MDA C Technical Team Project
Meeting Summary - Technical Team Meeting #1
March 20, 2019

Attachment 2: NMED Draft Comment on MDA C CME

Comments on groundwater-related issues in CME for MDA C

Figure 3 Tier II screening levels for TCE as a function of depth

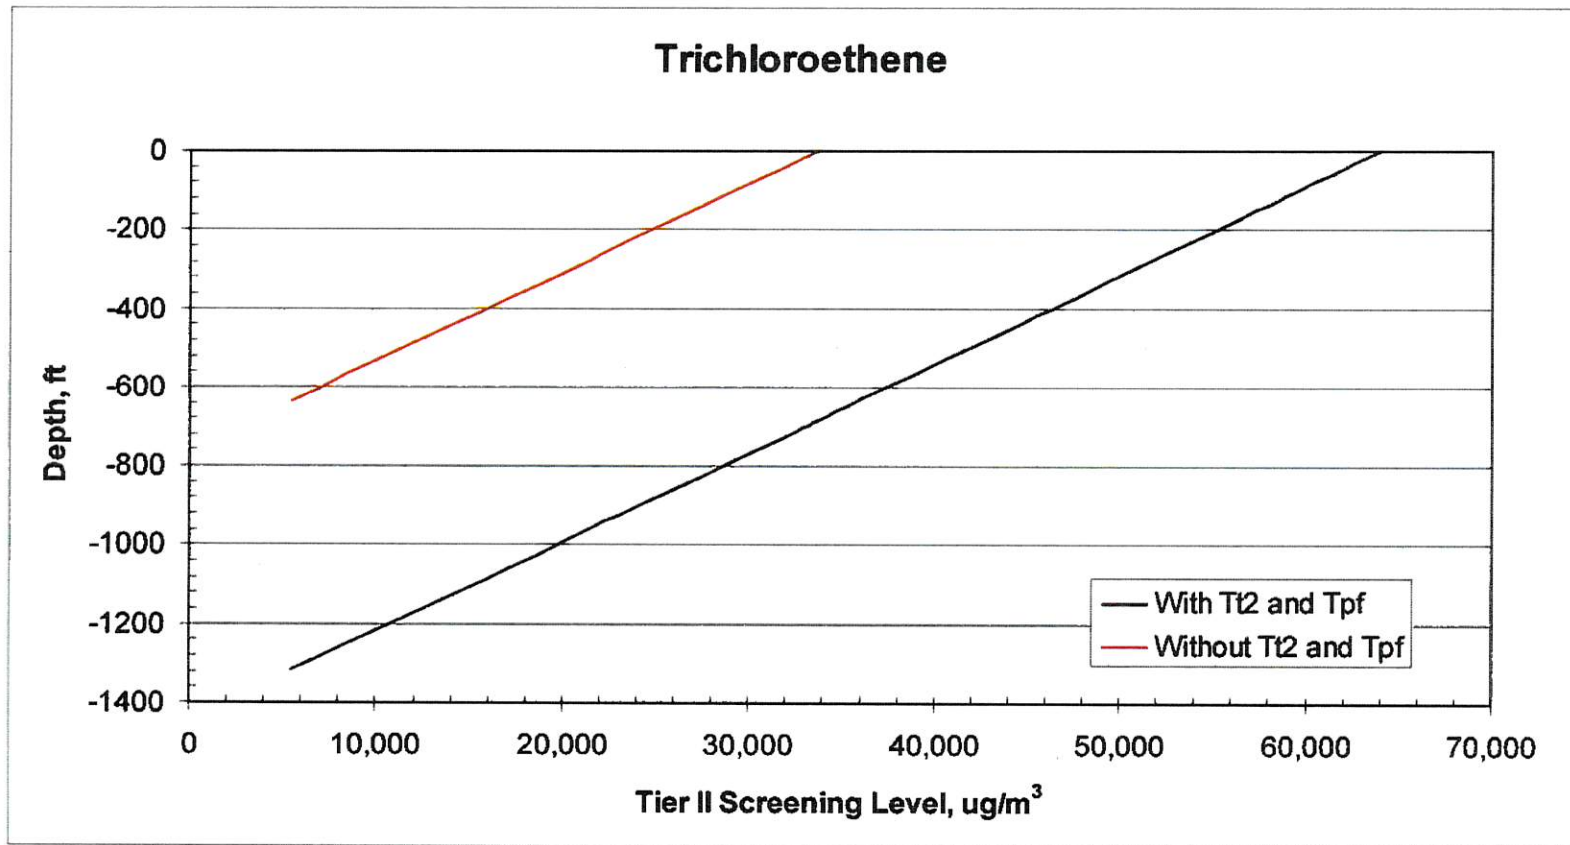
- c. Handout for Tier II Screening Levels for TCE as a Function of Depth. See Attachment 4. N3B to research the depth dependency of screening levels for COPCs.
